Final Environmental Impact Report

# Vallco Special Area Specific Plan

SCH# 2018022021

August 2018

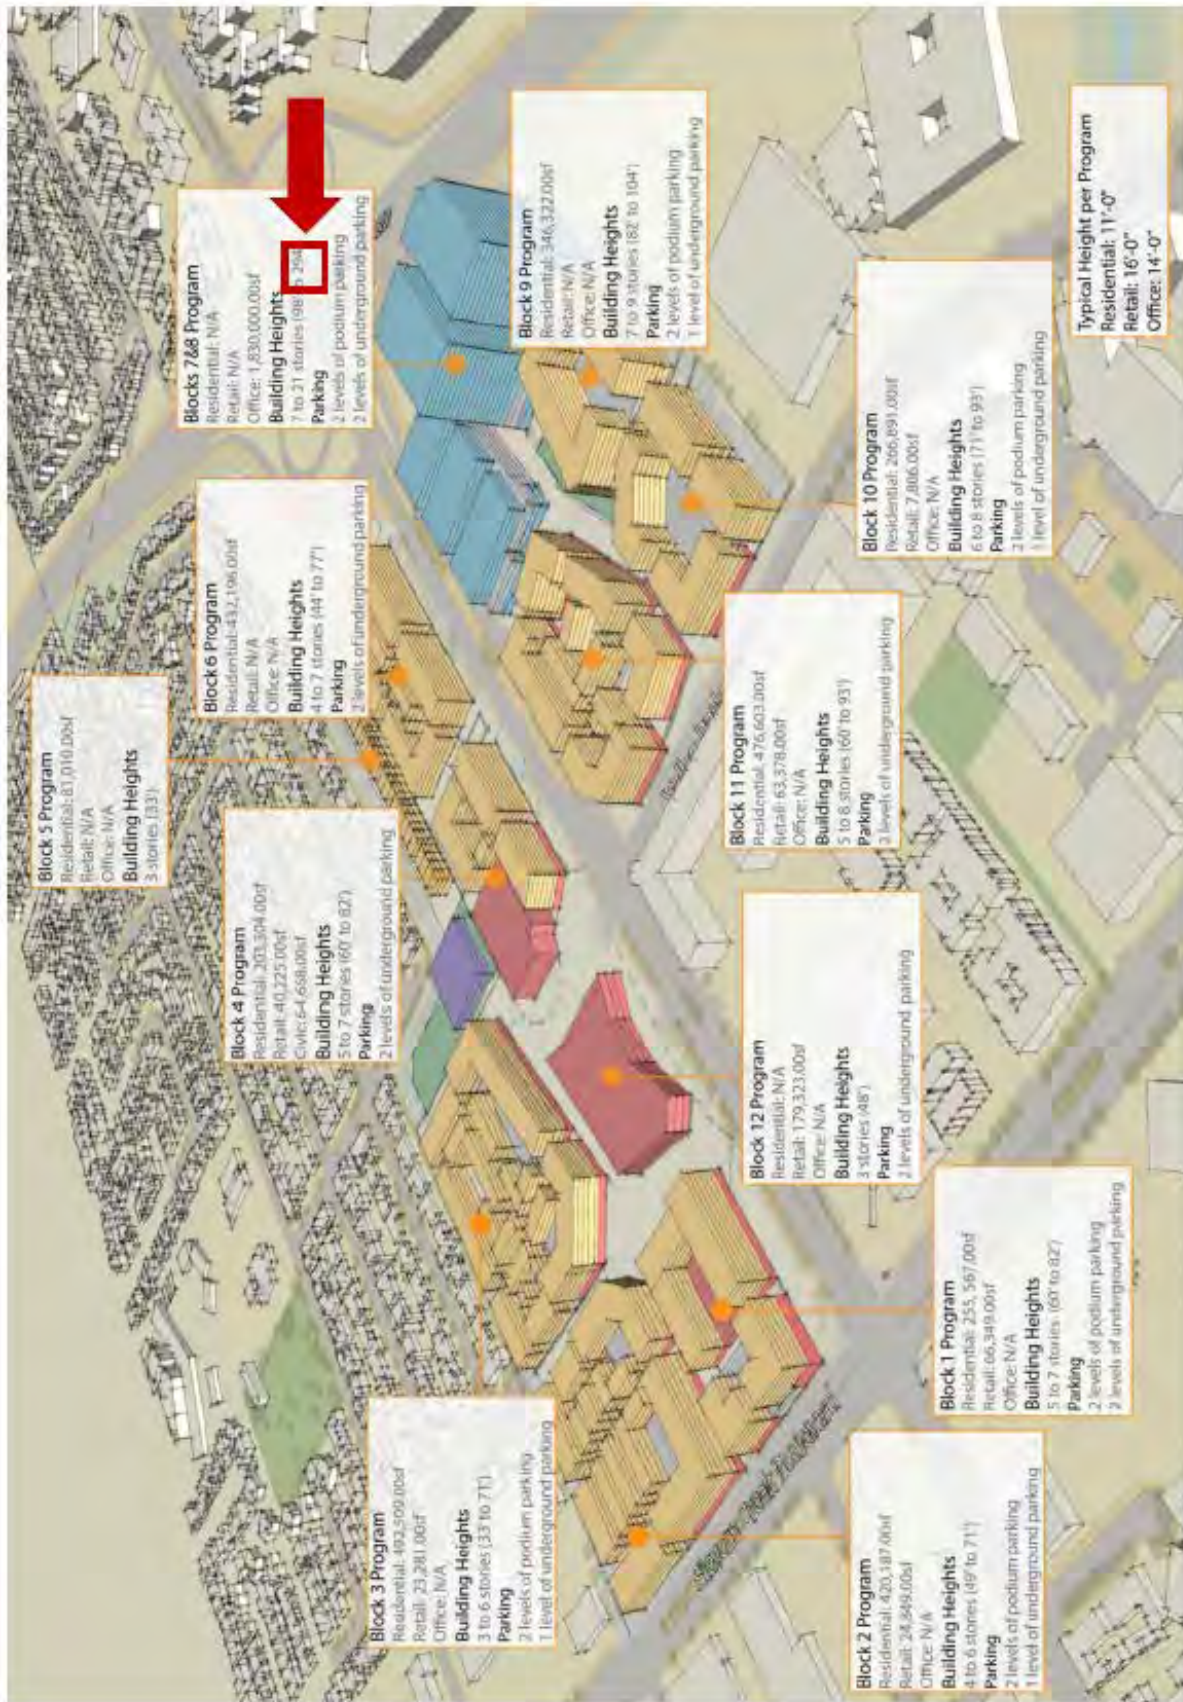
**Comment F.16:** 4. To add to the confusion as to what the project may end up being, the maximum height was also shown to be 294'. These height differences will cause different shadow and intrusion issues, such as privacy intrusion into Apple Campus HQ which may be a security risk at the corporate headquarters, guest discomfort at the outdoor swimming pool at Hyatt House, and the lack of privacy for the area homes and back yards. In Section 4.2.1 of the DEIR, heights are shown up to 165'.

**Response F.16:** Refer to Section 5.2 Response II.E.13.

Figure 25: AQI from BAAQMD

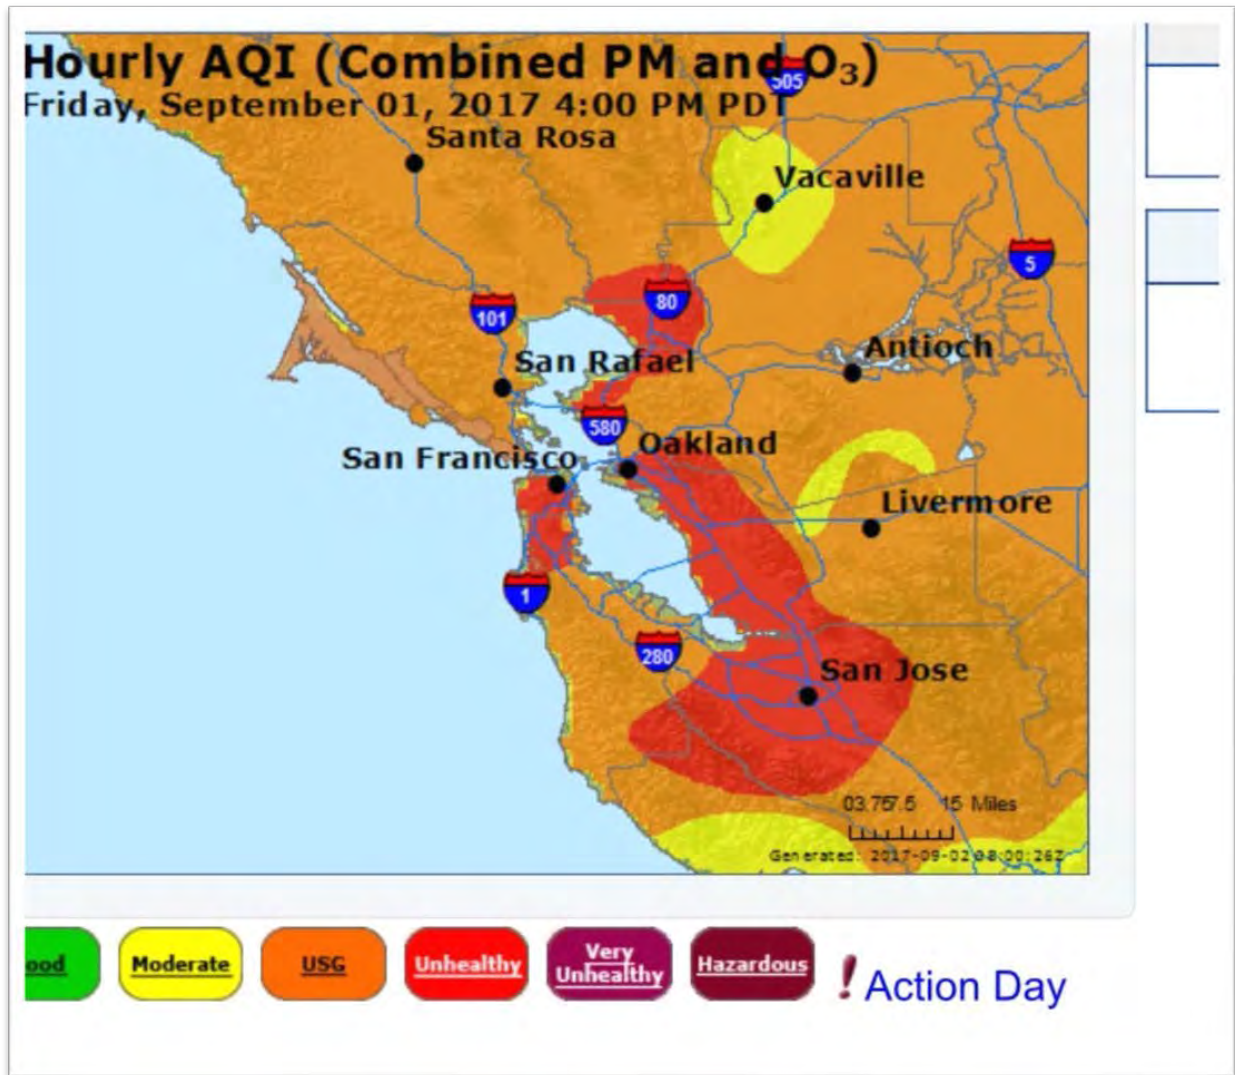
The cancer risk assessment is based on erroneous traffic studies and the air quality monitoring stations had old data from 2013 and/or were too far away to use data. The cancer risk needs to be recalculated. The amount of exposure time should reflect seniors not leaving the project area. The baseline air quality monitoring must be taken over an extended period with particular attention paid to the summer months when Ozone levels increase. Here is an example day when children would be playing outdoors, Ozone was the primary pollutant. Note these are regional amounts, and the increases along the freeways are not shown:

**Response F.56:** Refer to Section 5.2 Response II.E.53.

Figure 42: Opticos Charrette #2

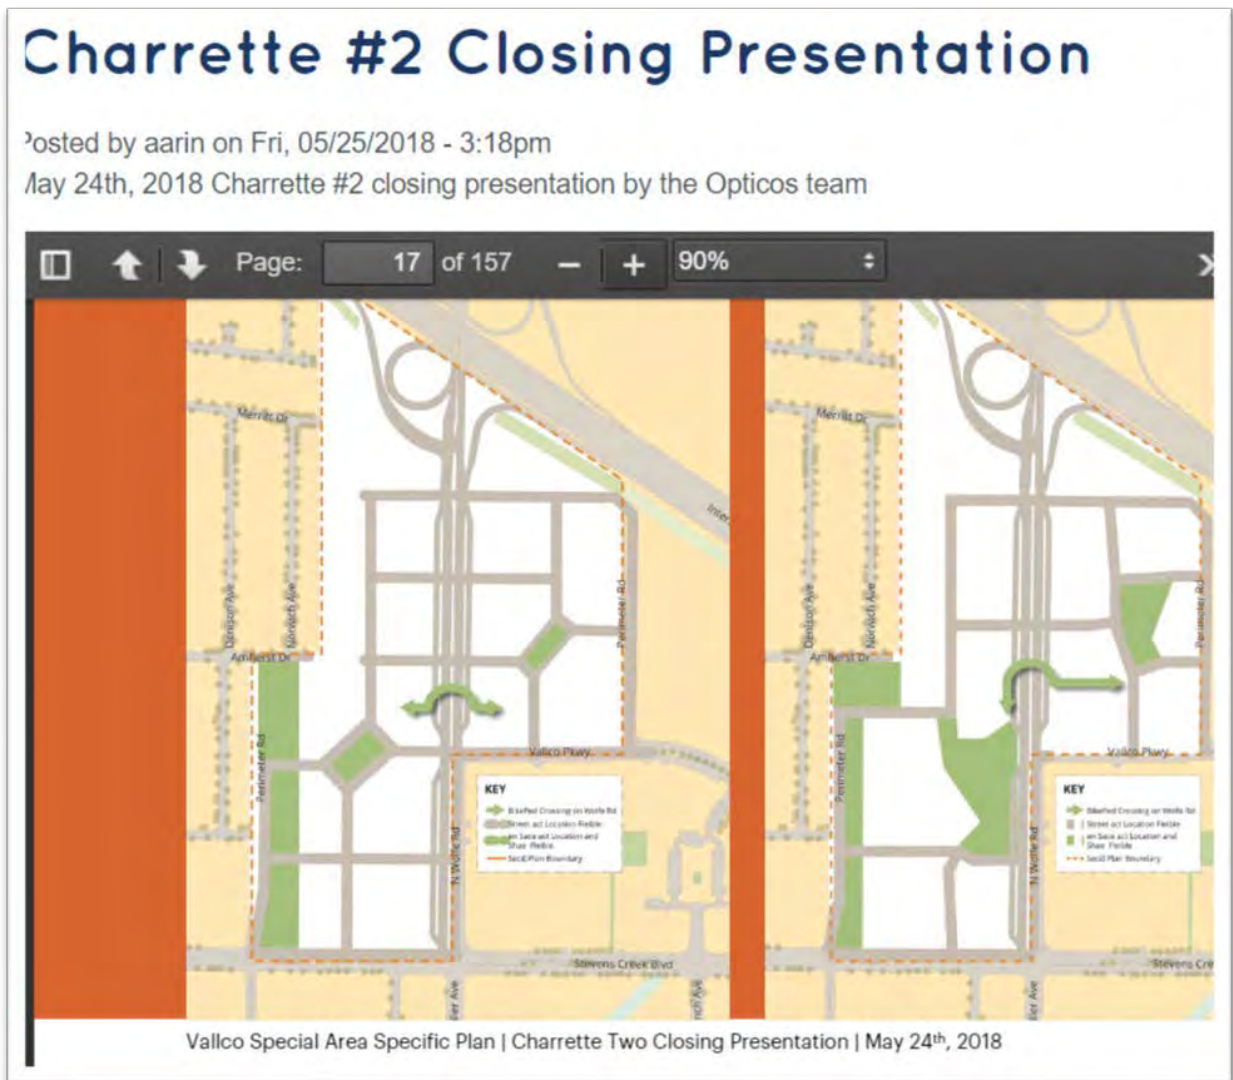
Charrette #2 Closing Presentation shows parks adjacent to back yards of single family residences. This may, combined with Perimeter Rd. noise exceed Municipal Code permissible sound levels. The DEIR does not adequately address this.

**Response F.108:** Refer to Section 5.2 Response II.E.105.

Figure 4: DEIR Heights

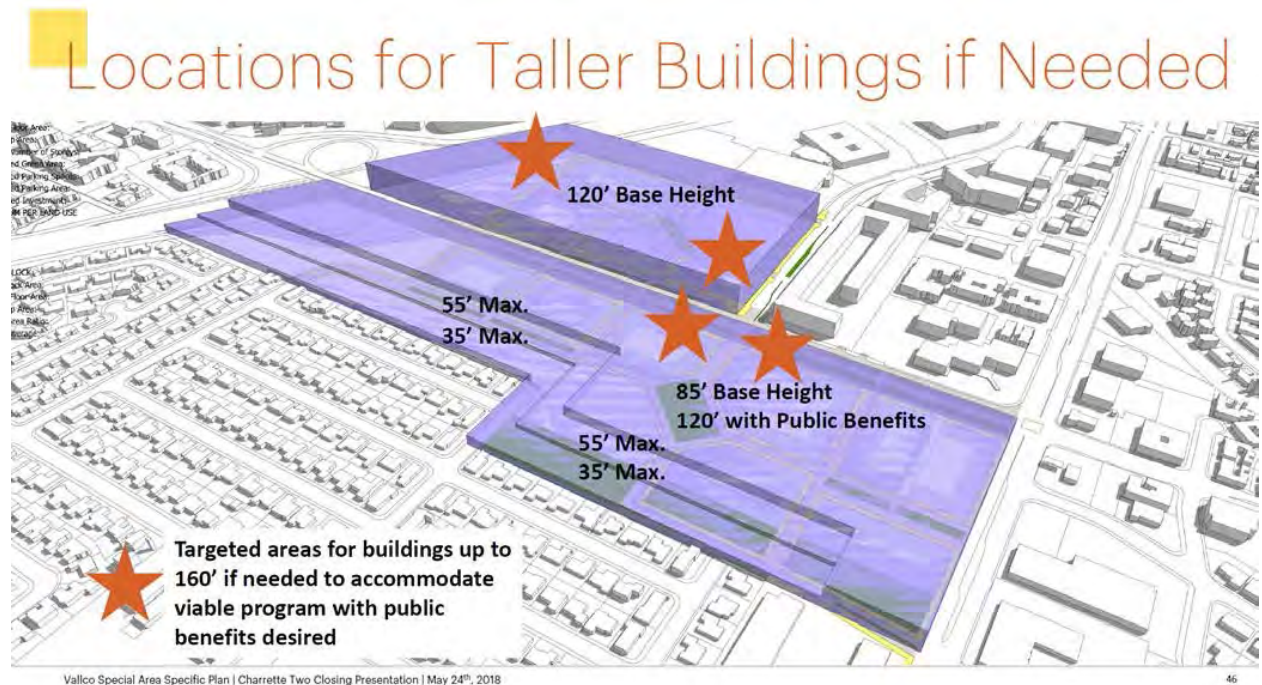
**Comment G.14:** 3. 65,000 SF of civic space, STEM lab, and 30 acre green roof were not discussed in the NOP period for Vallco. In the DEIR civic space and STEM lab are combined into the 65,000 SF. Additionally, the civic/STEM spaces are considered public benefits which would result in higher building heights if the developer includes them. This was mentioned at the Opticos Charrette #2 closing presentation, May 24, 2018:

**Response G.14:** Refer to Section 5.2 Response II.E.12.

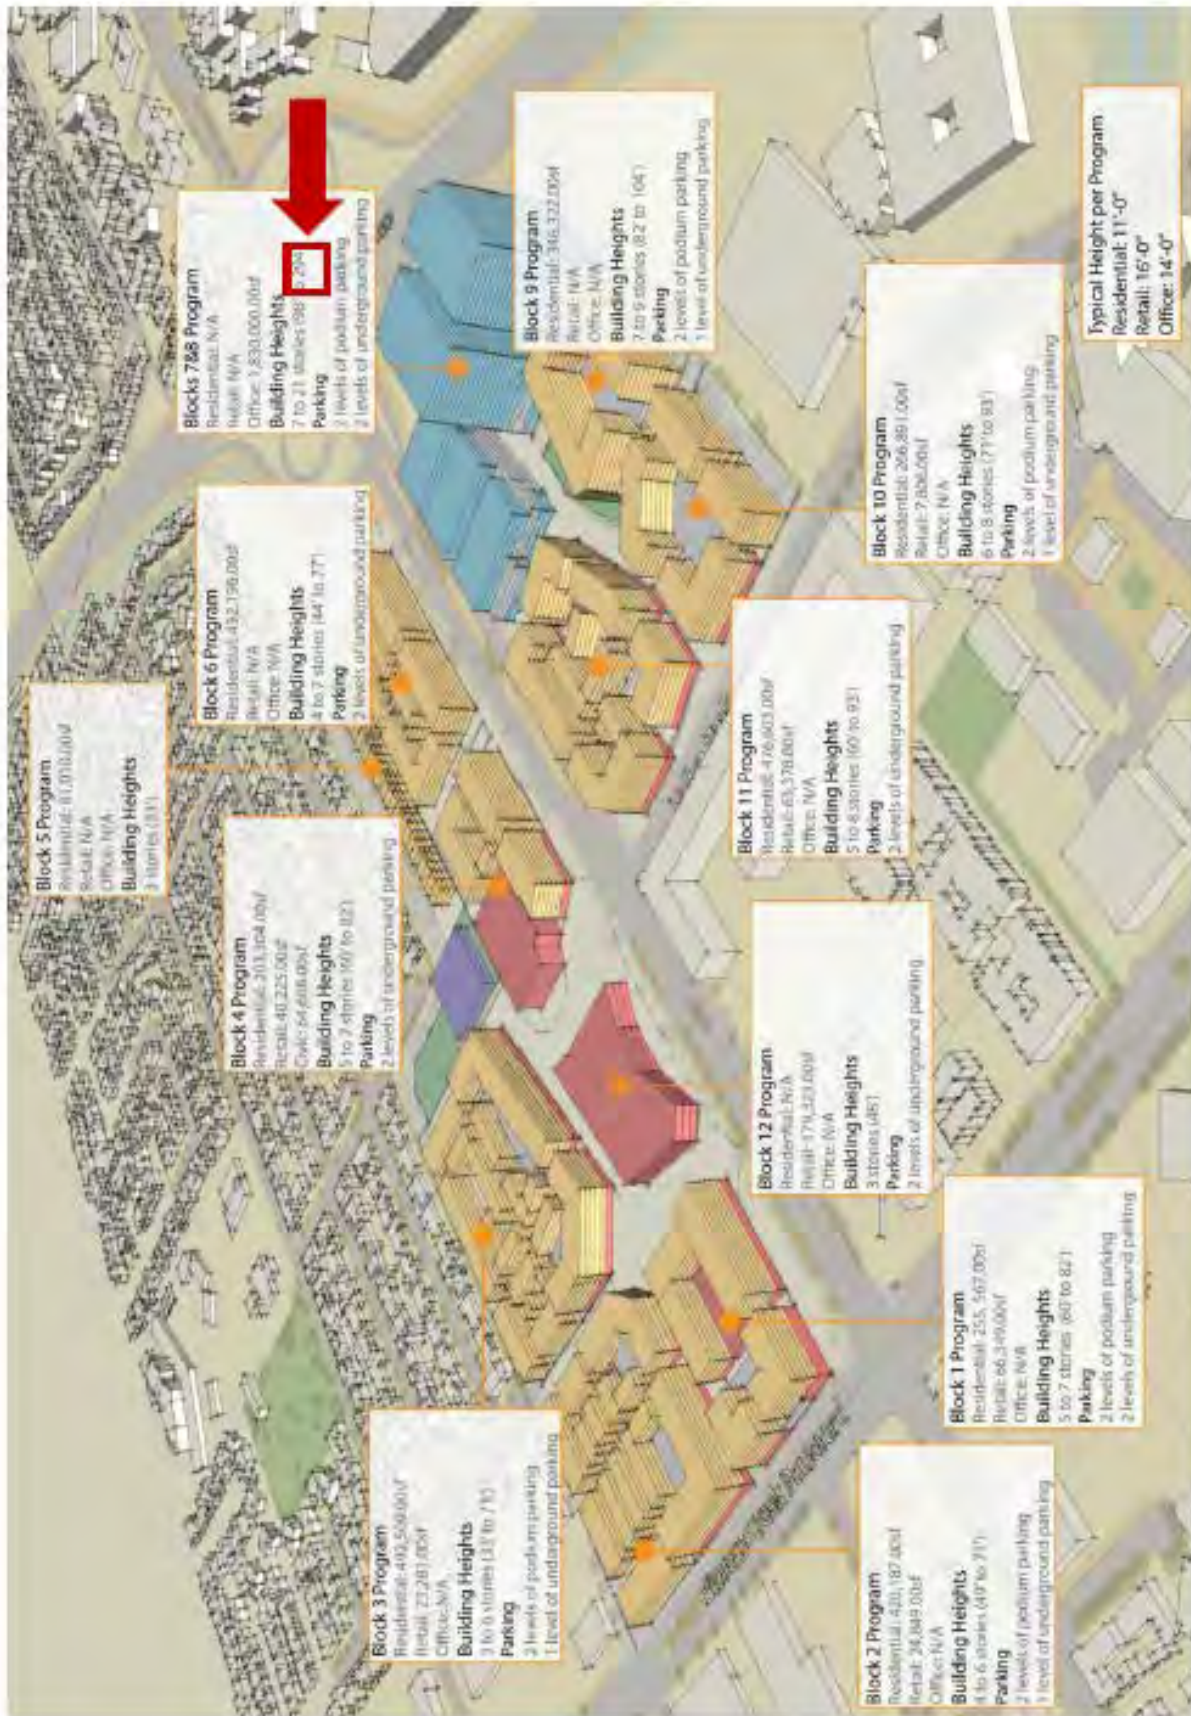
**Comment G.15:** 4. To add to the confusion as to what the project may end up being, the maximum height was also shown to be 294'. These height differences will cause different shadow and intrusion issues, such as privacy intrusion into Apple Campus HQ which may be a security risk at the corporate headquarters, guest discomfort at the outdoor swimming pool at Hyatt House, and the lack of privacy for the area homes and back yards. In Section 4.2.1 of the DEIR, heights are shown up to 165'.

**Response G.15:** Refer to Section 5.2 Response II.E.13.
